Submissions and Preferred Infrastructure Report

Newcastle Inner City Bypass
Rankin Park to Jesmond

Newcastle Inner City Bypass – Rankin Park to Jesmond Submissions and preferred infrastructure report

Roads and Maritime, as the proponent of the project, has prepared this submissions and preferred infrastructure report to respond to issues raised in submissions and describe and assess design refinements made since the exhibition of the EIS.

Figure 5-8c
Construction ancillary facilities

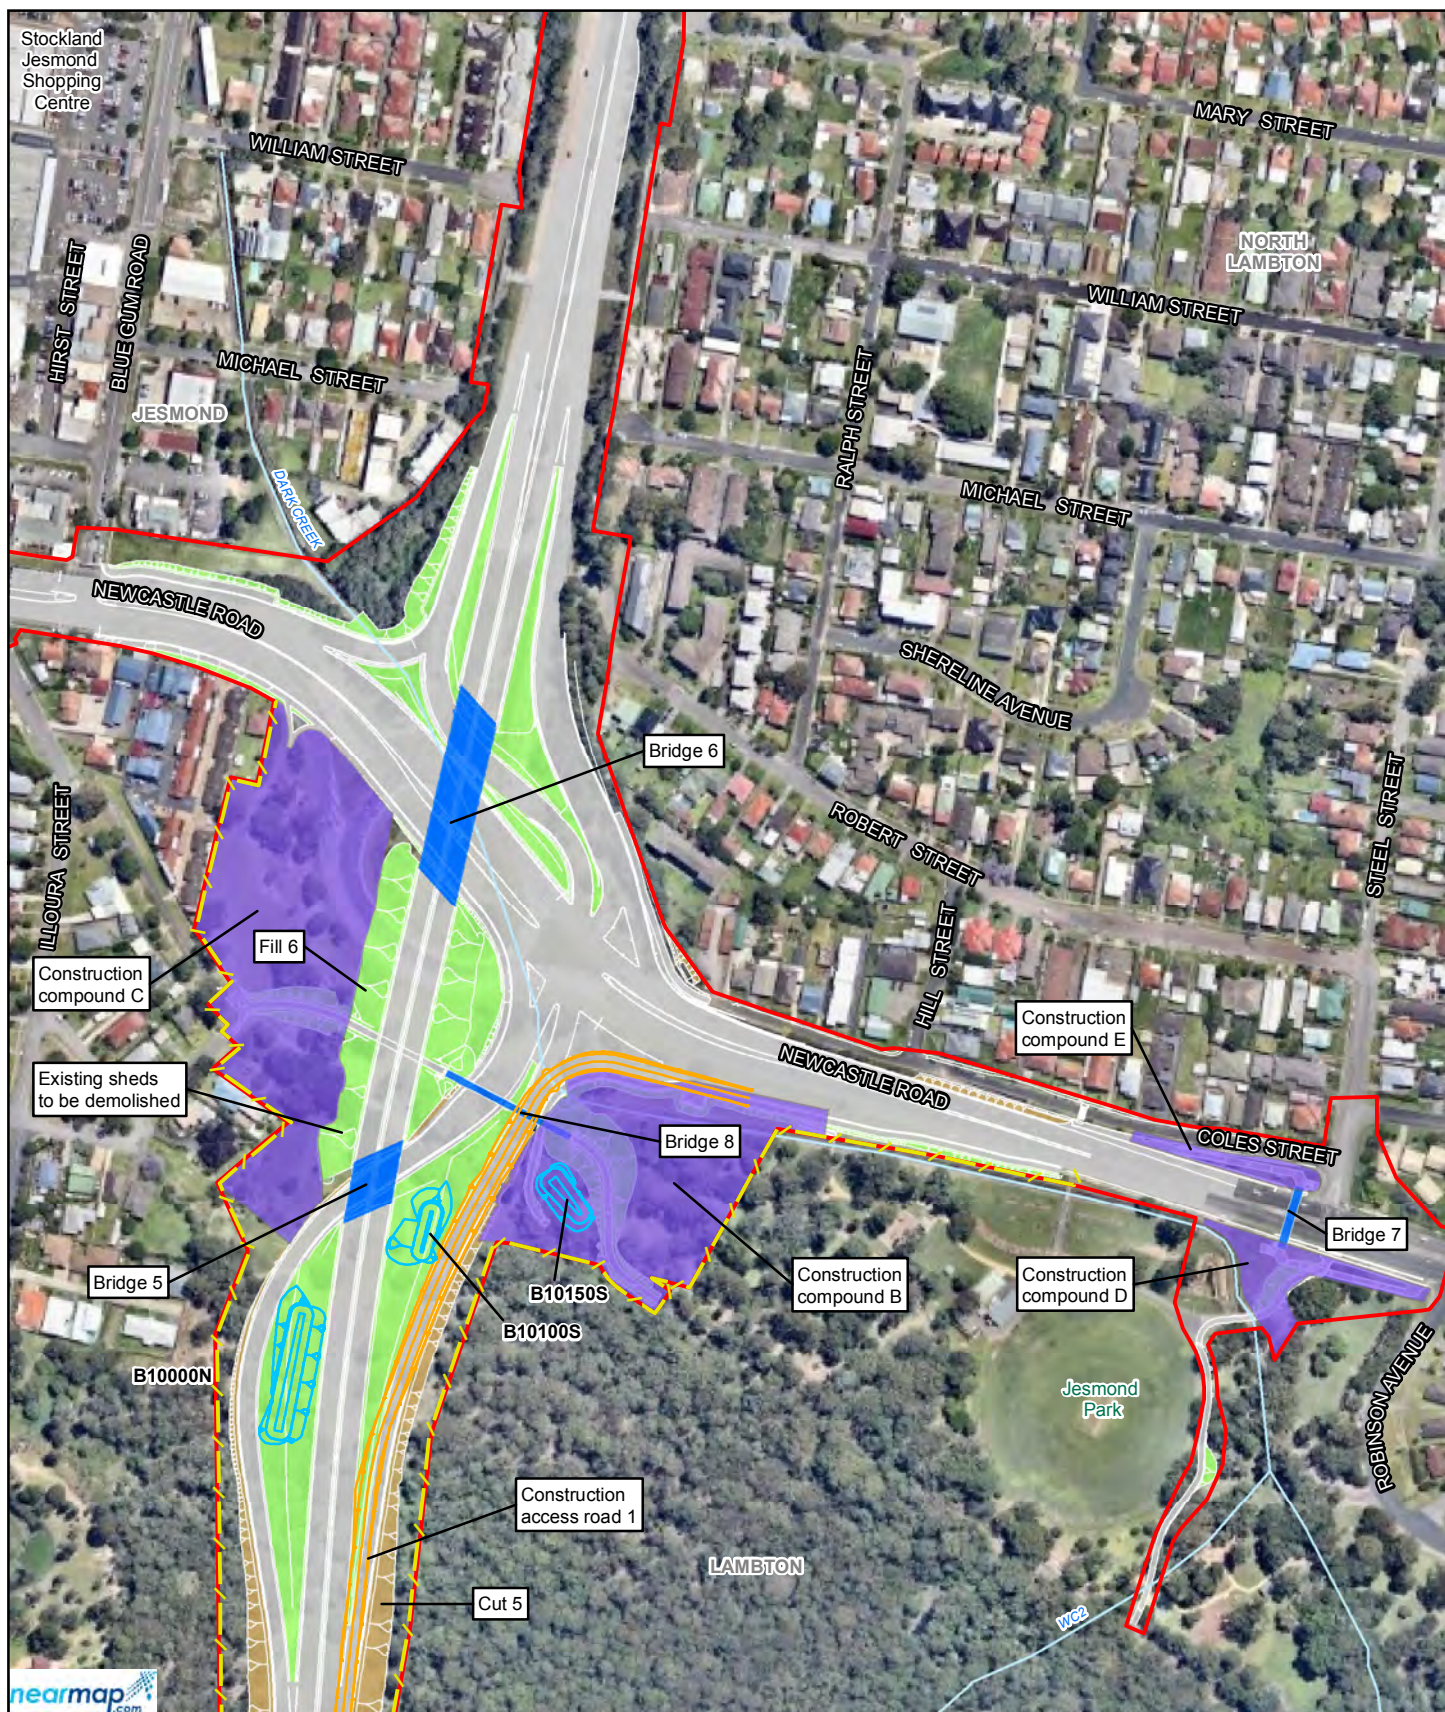
The locations of the construction compounds are shown in Figure 5-8 and a description is provided in the following sections. They have been located based on:

Compound B is about 1.3 hectares (increased by about 0.05 hectares) (it is noted there was a typographical error in the EIS which stated the area was 1.5 hectares) in area and is located next to the northern interchange (Figure 5-8). Access to this construction compound would be via a temporary access arrangement from or near the existing Jesmond roundabout.

Compound C is about 1.7 hectares in area (increased by about 0.06 hectares) and is located next to the northern interchange (Figure 5-8). Access to this construction compound would be via a temporary access arrangement from or near the existing Jesmond roundabout.

Compound D (new compound) is about 0.2 hectares in area and is located near the eastern end of Jesmond Park on the southern side of Newcastle Road (Figure 5-8). Access to this construction compound would be via Robinson Avenue and/or temporary access arrangement from Newcastle Road.

Compound E (new compound) is about 0.1 hectares in area and is located near the intersection of Coles Street and Steel Street on the northern side of Newcastle Road (Figure 5-8). Access to this construction compound would be via Steel Street, Coles Street and/or temporary access arrangement from Newcastle Road.

Compound F (new compound) is about 0.9 hectares in area and is located near the southern interchange on the western side of Lookout Road (Figure 5-8). Access to this construction compound would be via Lookout Road and/or McCaffrey Drive.

Due to other design refinements, during construction there will be still be about 16 sedimentation basins but some would be in new locations to capture sediment laden runoff from construction areas (Figure 5-8).

Indicative 3D image of Bridge 2 - McCaffrey Drive, looking north

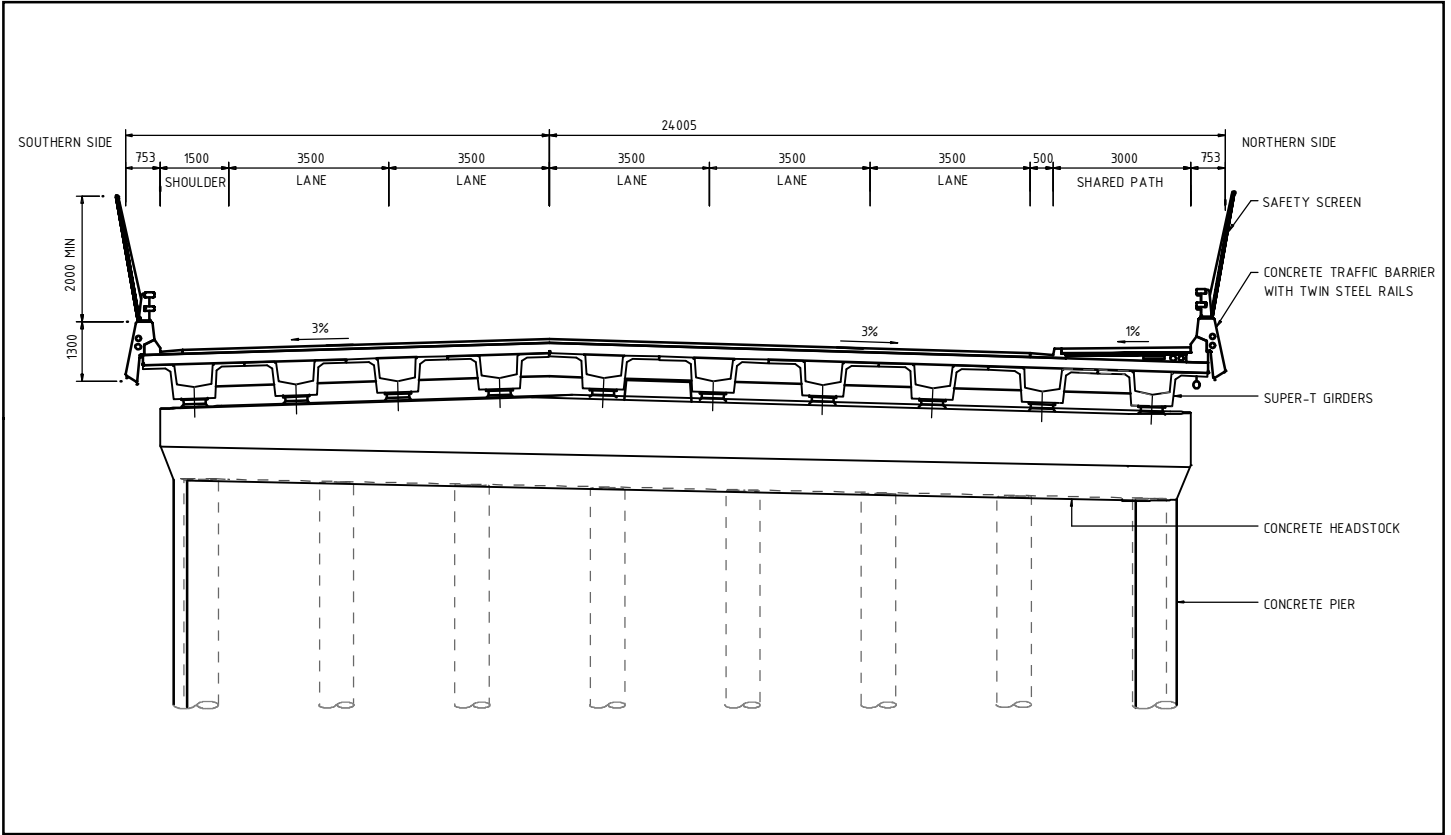
The refined design for Bridge 2 is shown in Figure 5-9.

Indicative 3D image of Bridge 3 - hospital interchange, looking north

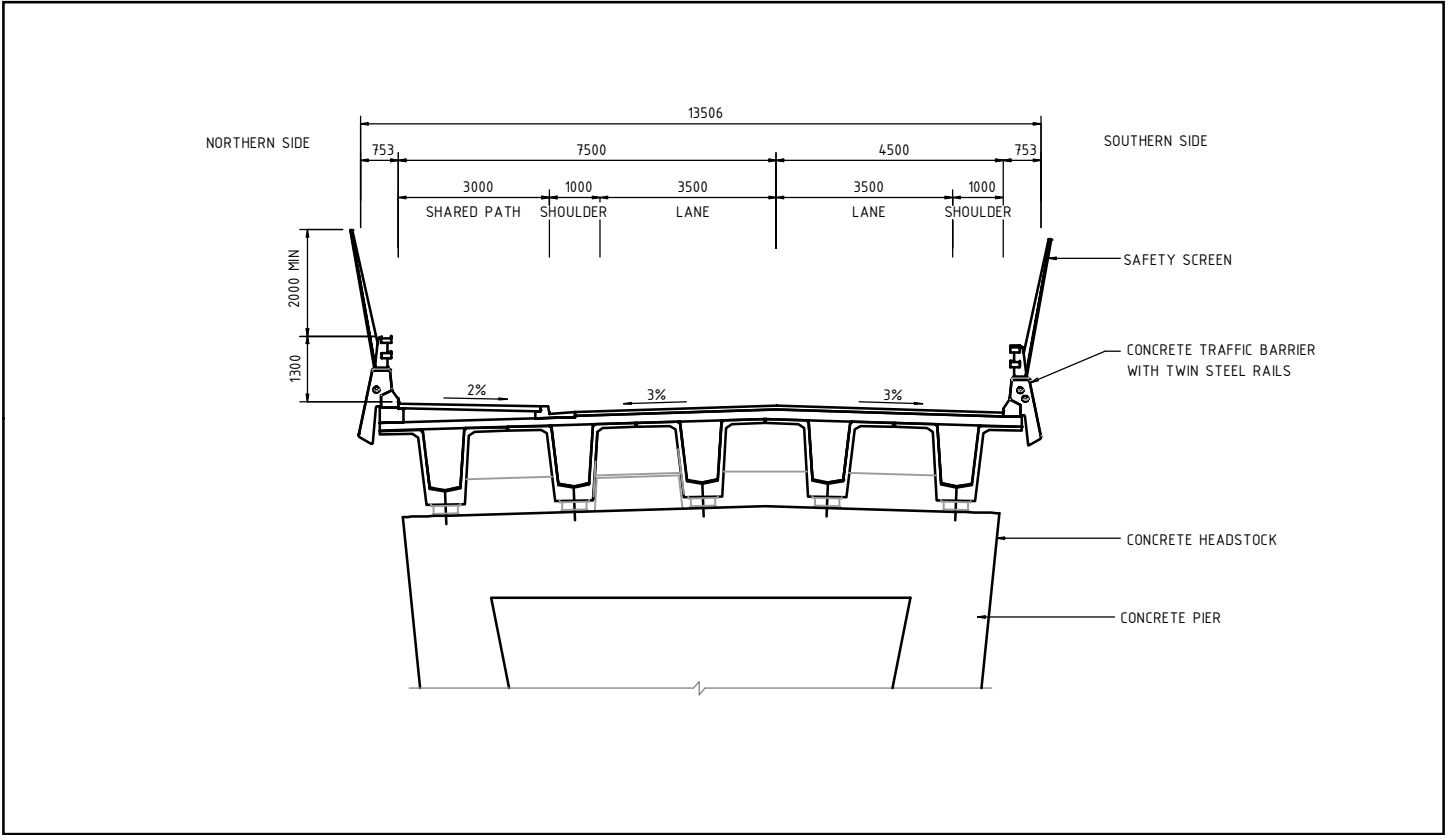
The refined design for Bridge 3 is shown in Figure 5-10.
